service bulletin

M77-19

SUBJECT: Intake and Exhaust Rocker Arm Identification and Application

AFFECTED: C-75, C-85, C-90, C-125, C-145, O-200 and O-300 Series Engines

FIGURE 1

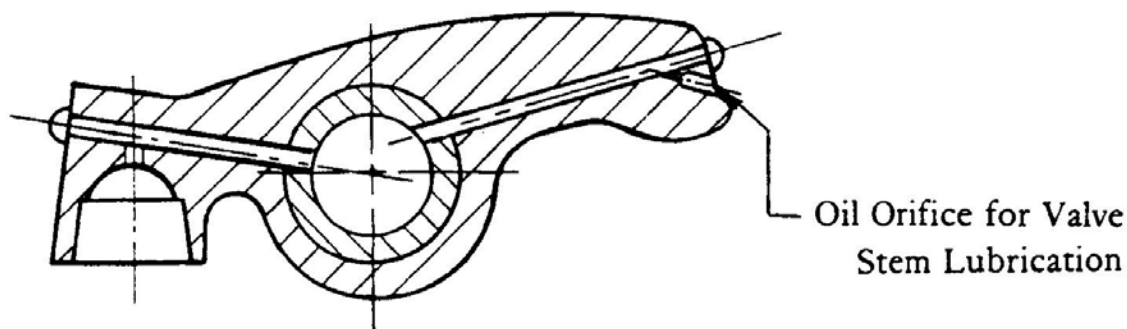
It has been brought to the attention of Teledyne Continental Motors Aircraft Service Department that on occasion intake and exhaust rocker arms are not being installed in their proper respective positions during servicing of the above mentioned model engines.

We wish to point out that intake rocker arms, Teledyne Continental Motors part number 639614, do not have an oil orifice drilled in the valve stem end of the rocker arm as does the exhaust rocker arm, Teledyne Continental Motors part number 639615. The oil orifice as evident in Figure 1 provides needed lubrication to the exhaust valve stem during engine operation. Caution notes regarding this subject should be placed in your Teledyne Continental Motors Overhaul Manuals Form Number X-30013 dated July, 1970, or earlier and Form Number X-30010 dated April, 1973 or earlier.
